For DA/2022/1279/1 Council and the applicant have failed to come to an agreement in respect of the following conditions:

Figure 3: Typical Sub-Arterial Road

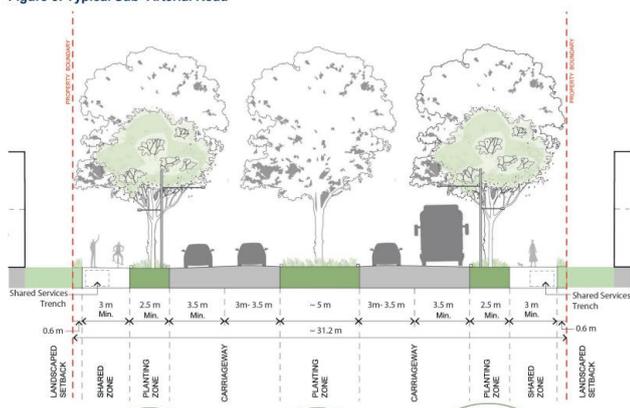
Council had previously understood that the applicant had agreed to 3m sharepaths as per request for information (RFI) response dated 8 September 2023 (page 4).

Council notes that the WGA DCP 2021 requires the design of streets to be consistent with the sections set out in Figure 3 to Figure 8. Figure 3 provides for the cross section for the sub-arterial road, this requires provision of two 3m shared paths:

The earlier section of the sub-arterial road approved with DA/2019/662/1 has also been conditioned for a 3m share paths either side of the road. This section of the sub-arterial will follow on from DA/2019/662/1 and it is logical for the 3m wide footpath to continue.

There is adequate room within the verge to accommodate the 3m wide footpath, infrastructure and landscaping.

It is noted that applicant has pointed to Neighbourhood Plan No.1 potentially prevailing over the 3m wide path requirements. Council is not in agreement. Section 2.5 of Neighbourhood Plan No.1, references compliance with movement section of the WGA DCP. The 2.5m paths referenced apply to the proposed pedestrian/cycle green path network shown as the green dotted line on Figure 4 (within the subdivision and around bushland).

1. Shared use Pathways on the sub arterial road (Road 108) must be increased to a minimum 3.0 metres wide.

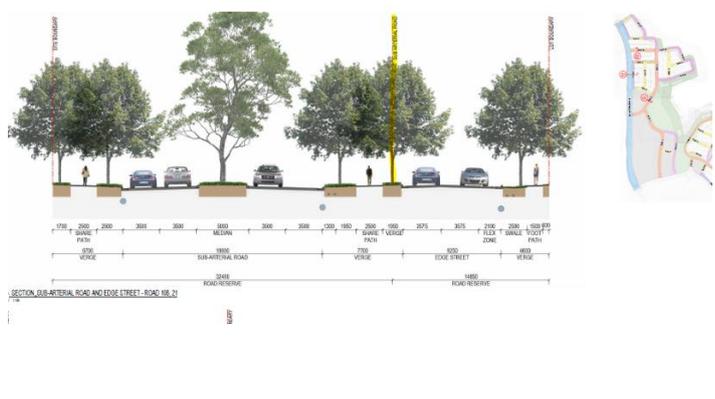
*Regarding the shared path in the sub-arterial road, our intent with the last RFI response was to ensure 2.5m shared paths on either side of the road to provide adequate room on either side of the shared path in the verge for landscaped area for a boulevard of trees on either side of the shared paths.*

*A 2.5m shared path is a much better outcome as there is less hardscape with additional room for soft landscaping on either side of the path, particularly for a higher order road, increasing the overall look and feel of the streetscape. The less concrete / hardscape, the better as we are conscious of the heat island effect.*

*See below section from the latest landscape plans – note for the eastern side of the sub-arterial road, we had intentionally ensured continuity and cohesiveness to where it adjoins the local road (i.e. road 21 and road 27). This intent would not work with a 3m shared path.*

*There will be also less landscaped area for two trees on either side if the shared path was to be 3m - noting that for the local roads, the landscaped area in the verges for trees range from 1.65m-2.5m.*

*The North Wilton NP1 in the DCP originally showed on-street cycle paths on the sub-arterial road which was 3m, however it references a minimum shared path width of 2.5m (it is not referencing that it only applies to shared paths within the bushland – it is a blanket control applying to all shared paths). Given Council are now requesting shared paths for the sub-arterial road, we have applied the minimum 2.5m for shared paths.*
